REVISED SCHEME FOLLOWING COMMENTS 10.09.26

S.G ARCHITECTURAL DESIGN
Tel: 07817034426. sgarchitecturaldesign@gmail.com.
www.sgarchitecturaldesign.com

Yelna - Broadholme Lane - Belper - DE56 2JF

04 - REVISED V1 ELEVATIONS

Datum: 75.00m.
Elevation 3.

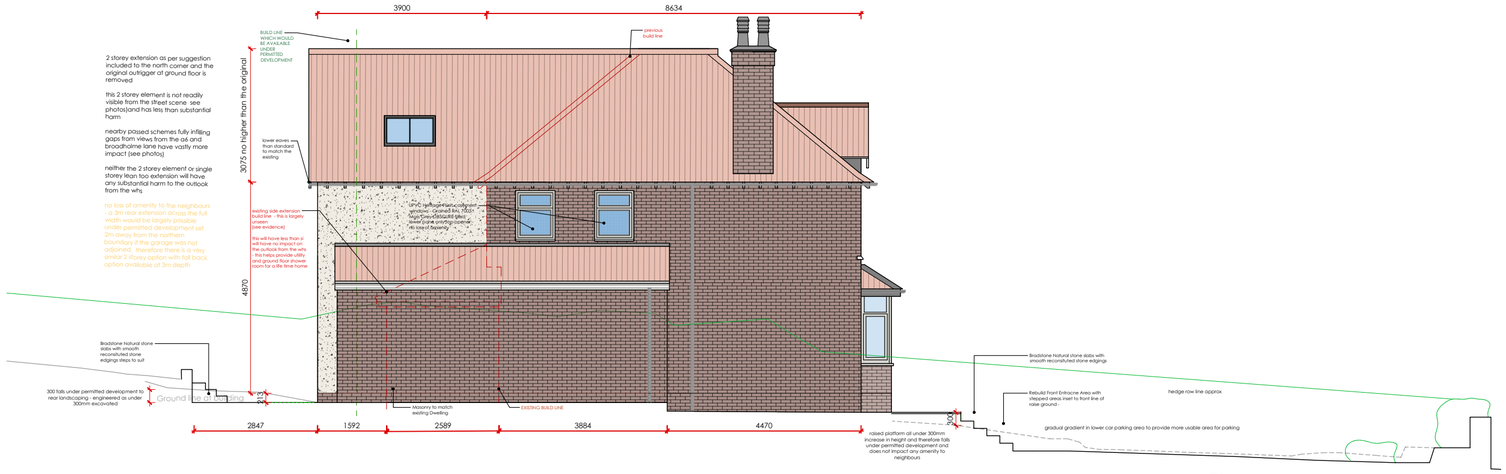
2 storey extension as per suggestion included to the north corner and the original outrigger at ground floor is removed

this 2 storey element is not readily visible from the street scene (see photos)and has less than substantial harm

nearby passed schemes fully infilling gaps from views from the a6 and broadholme lane have vastly more impact (see photos)

neither the 2 storey element or single storey lean too extension will have any substantial harm to the outlook from the whs

no loss of amenity to the neighbours - a 3m rear extension across the full width would be largely possible under permitted development set 2m away from the northern boundary if the garage was not adjoined. therefore there is a very similar 2 storey option with fall back option available at 3m depth
